Subject: Traffic Control Plans for Rodeo Grounds Berm Removal

File: Topanga Cyn Blvd (Rte 27)
Rodeo Grounds Berm Office
Removal
IGR/CEQA # 060119/EK

Subject: Comments on Traffic Control Plan

TH-2

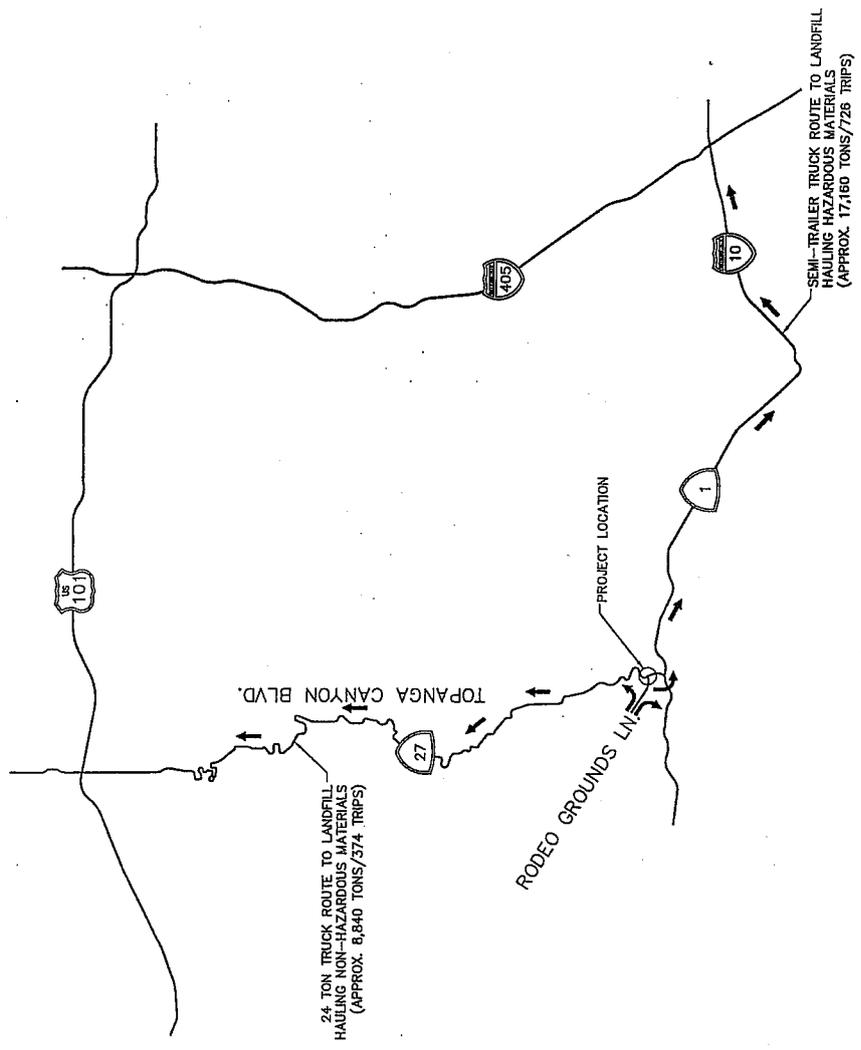
1. It is preferable that all the hauling truck traffic be routed by way of Pacific Coast Highway (Route 1) rather than Topanga Cyn Blvd (Route 27) due to the roadway geometrics, such as curves, narrow width, etc., of Topanga Cyn Blvd. Also, a project to widen and resurface the roadway from Pacific Coast Highway to Mulholland Dr is currently under construction. Lane closures are performed using reversible control. Therefore, delays are common. This project is scheduled to be completed March 30, 2007. If the Rodeo Grounds Berm removal project is scheduled within the same time, the delays may be excessive, both for the trucks and the everyday motorists.

2. All work shall be conducted during the Hours of Operation, as shown on TH-2.
3. Two (2) flaggers shall be onsite at all times during the hours of operation, (one for each direction of travel).

The Caltrans District 7 letter of September 13, 2006 also mentioned that "it is preferable that all the hauling truck traffic be routed by way of Pacific Coast Highway (Route 1) rather than Topanga Canyon Boulevard (Route 27) due to the roadway geometrics, such as curves, narrow width, etc., of Topanga Canyon Boulevard." Only those Rodeo Grounds trucks with

sufficient power and lighter loads will use the Topanga Canyon Boulevard route. All other trucks, and those with hazardous materials, will use the Pacific Coast Highway route.

The Caltrans September 13, 2006 letter also mentions that a road widening and resurfacing project for Topanga Canyon Boulevard that will be completed March 30, 2007 may cause delays for the trucks. The Rodeo Grounds berm removal is scheduled to take place after March 30, 2007, so the widening and resurfacing project would not cause traffic delays to hauling operations.
